CITY OF HOUSTON

HISTORIC PRESERVATION APPEALS BOARD
PLANNING & DEVELOPMENT DEPARTMENT

ITEM: II

APPLICANT: Valere and Nadia Costello, owners
PROPERTY ADDRESS: 443 Columbia St
LEGAL DESCRIPTION: LT 2 BLK 304 – Houston Heights
HISTORIC DISTRICT: Houston Heights South Historic District

Proposed Second Floor Plan

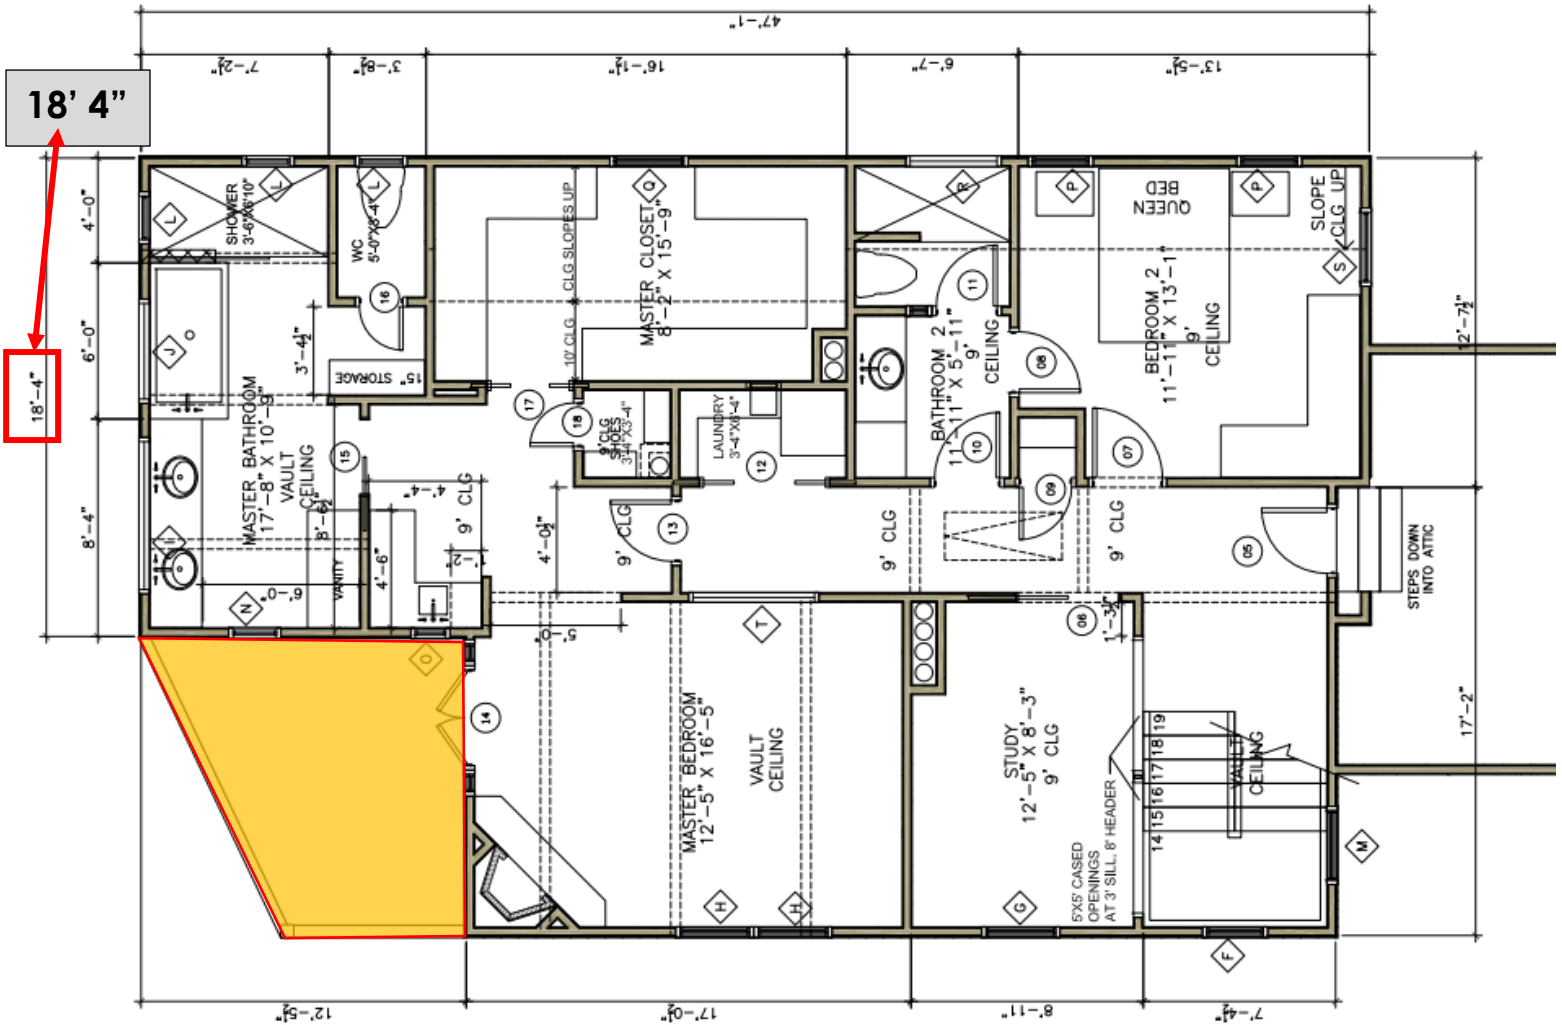
Area shaded in yellow is the second floor open balcony

Staff Jason Lilienthal: That would be correct.
And I will elaborate on that because based on that porch dimension is about 18.33 feet wide with a 10.92 feet depth to it.
That comes to a total of 200 square feet and that pushes it over the FAR.

Staff Jason Lilienthal: That would be correct. And if I could turn your attention to page 17 where I do the maximum floor area ratio, it says remaining amount to 70 without the square footage below the condition space and then you add in the 200, it's a - 130.

Proposed Second Floor Plan

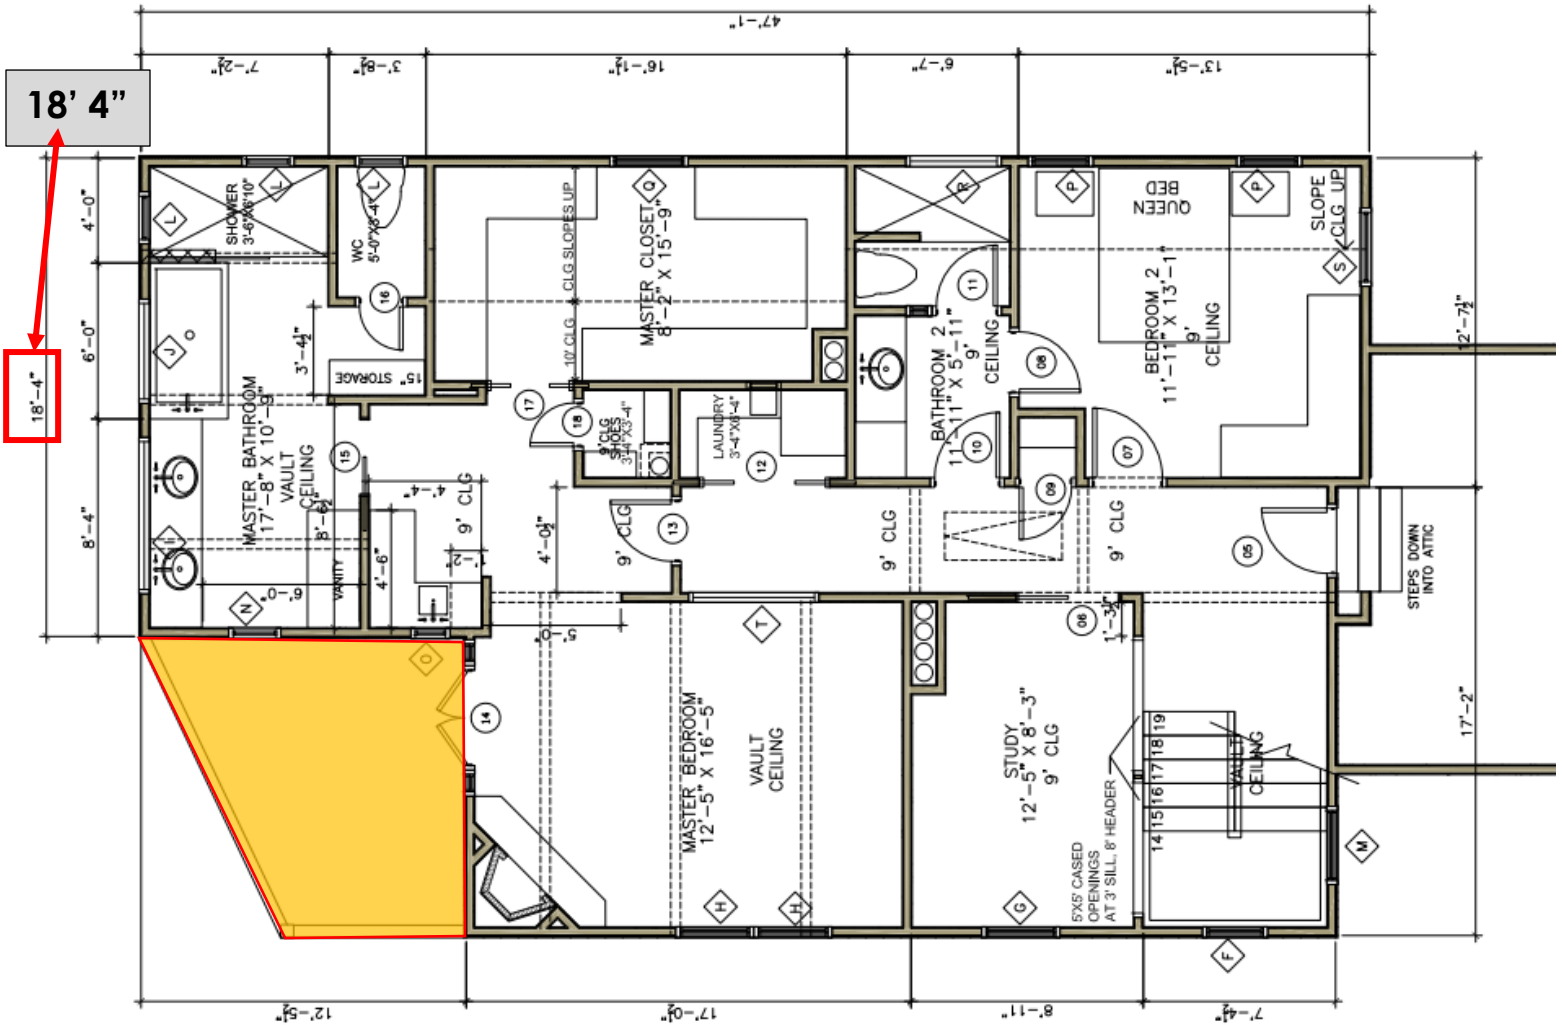
Area shaded in yellow is the second floor open balcony

Staff Jason Lilienthal: I'm going through my staff report. I have the measurable standards towards the end of the staff report after the elevation drawings and it would be on page 17. So it is still meeting maximum lot coverage but not the FAR. And I have included several numbers where I do stipulate that it says without the square foot below the conditioned space. But I do note that if you add that in it's a -130 if you add in that conditioned space.

Building Wall (Plate) Height (Addition and New Construction)

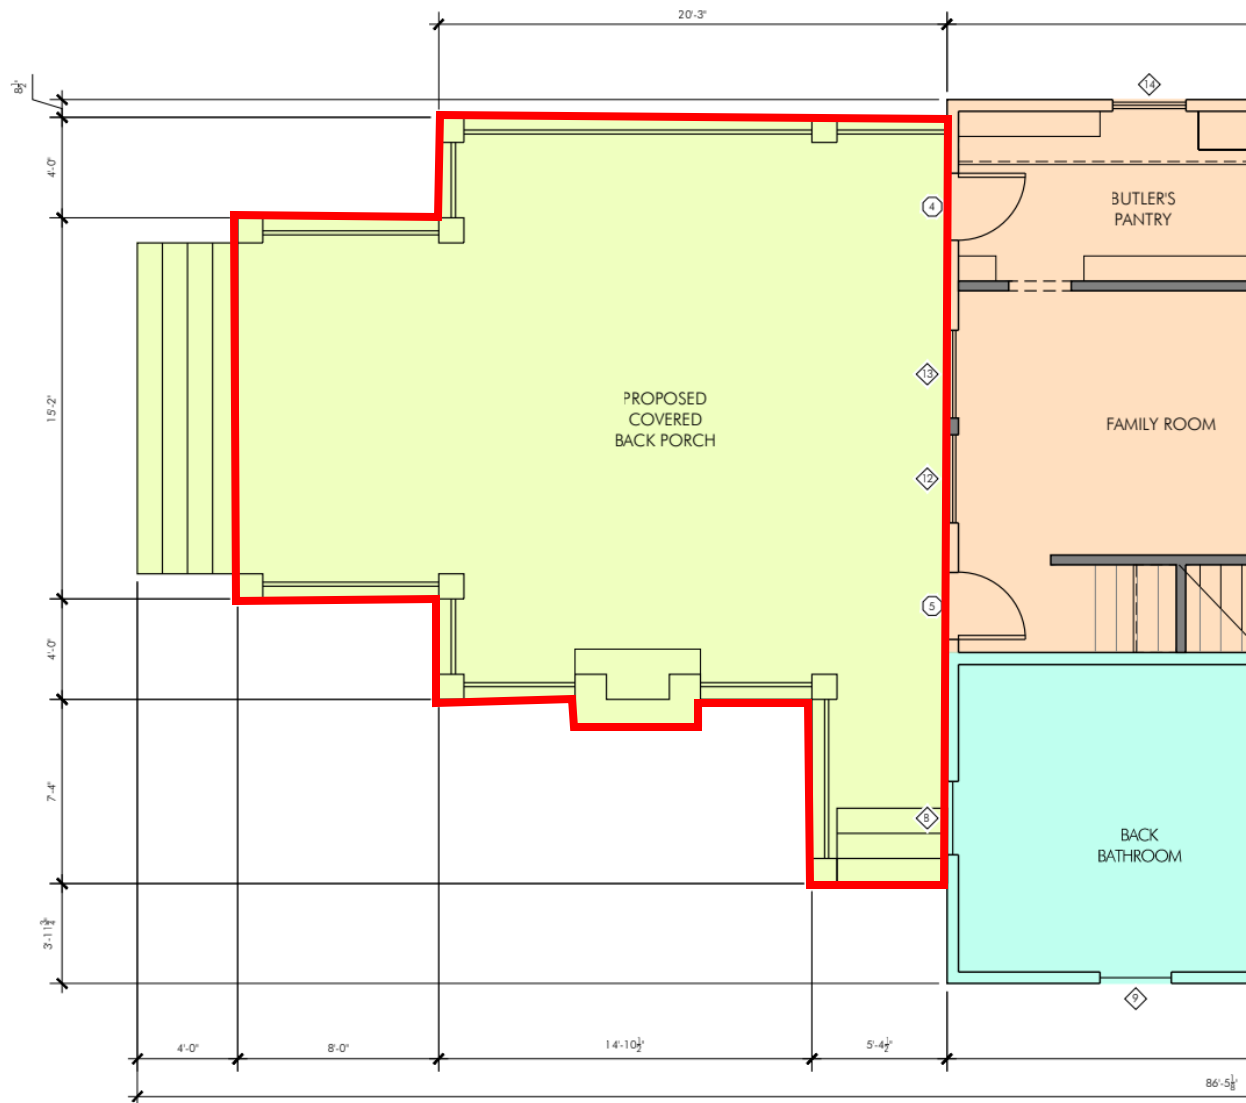
Proposed finished floor: 2'

Proposed second floor plate height on North elevation: 7' 6"
